REVIEW COMPLETION LETTER

Project Name: Point Wells Urban Center
Date of Letter: October 6, 2017
Files Numbers: 11-101457 LU (Land Use permit for site plan)
11-101461 SM (Shoreline Management permit)
11-101464 RC (Retaining Wall – Commercial)
11-101008 LDA (Land Disturbing Activity – grading)
11-101007 SP (Short Plat)
11-101457 VAR (Parking Variance)

Nature of Request: Urban Center development to include 3,080 residential units,
138,353 square feet of commercial space and other amenities.

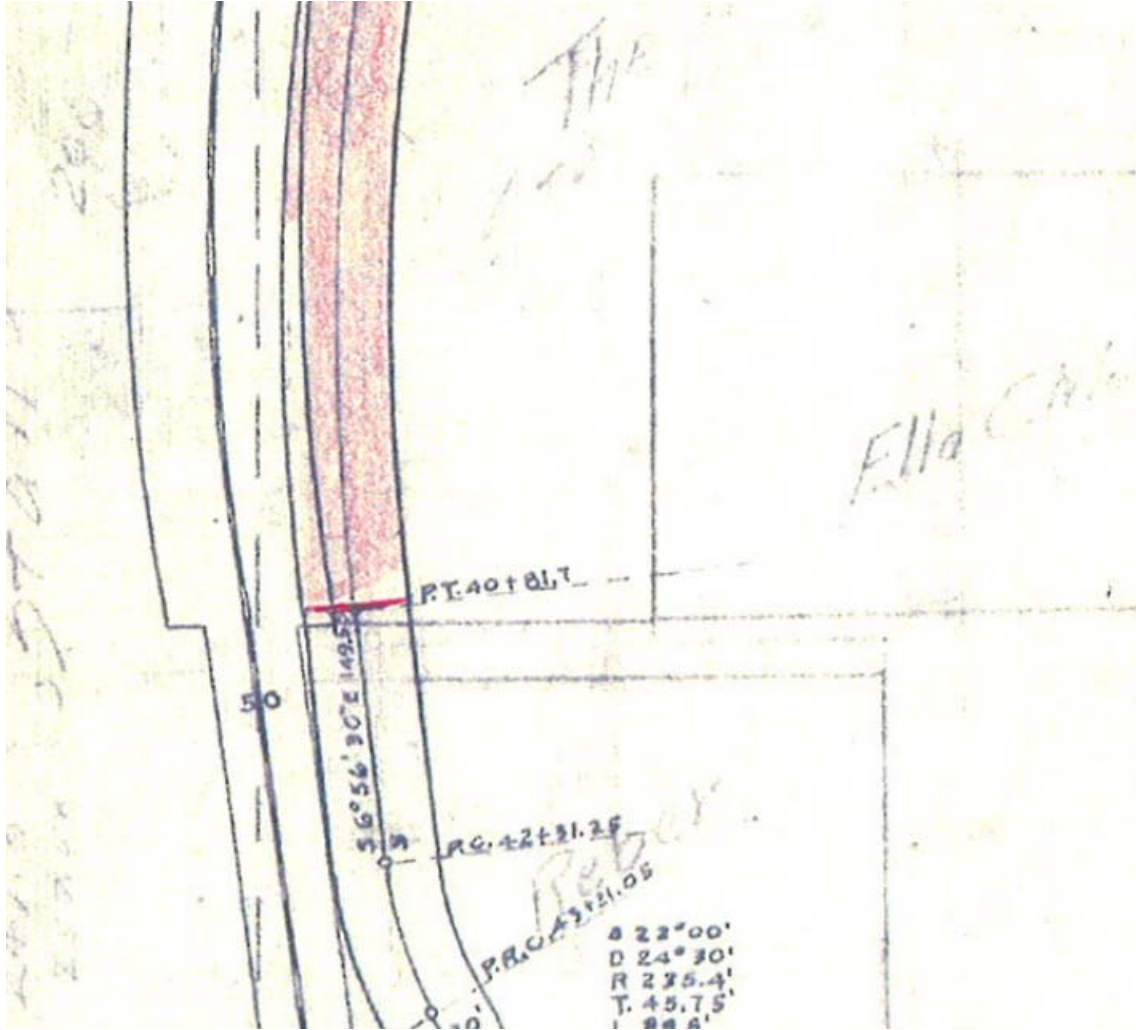
Urban Center Comment (ee): “The attached section of the Snohomish County Assessor’s parcel map appears to indicate that a narrow panhandle of parcel 270335-003-002-00 extends across the current access road to the subject site. Additionally, sheet EX2 indicates a 50’ access easement per King County Cause No 05-2-13678-1 on the west portion of the subject property. If the Assessor’s parcel map is correct, does this easement provide vehicular access rights across the narrow panhandle? If this access easement does provide access rights, please provide a copy of the recorded access easement demonstrating that the owner of the subject property has access rights across the panhandle.”

Evaluation of response to Comment (ee): The applicant did not respond to this comment.
Second request: A response is still required.

RESPONSE #30:

The depiction of the panhandle of parcel 270335-003-002-00 is shown in error. The original configuration of this lot did not include the referenced panhandle. It was added to this lot following the vacation of the Heberlein Road. The apparent assumption was that a portion of the vacated right-of-way would attach by operation of law to adjoining parcels. However, as is depicted below, the vacated (red) portion of Heberlein Road stopped just to the north of parcel 270335-003-002-00. The panhandle assumed to have been added to said parcel was in fact not vacated, is not part of the referenced parcel and remains a small stretch of county road.
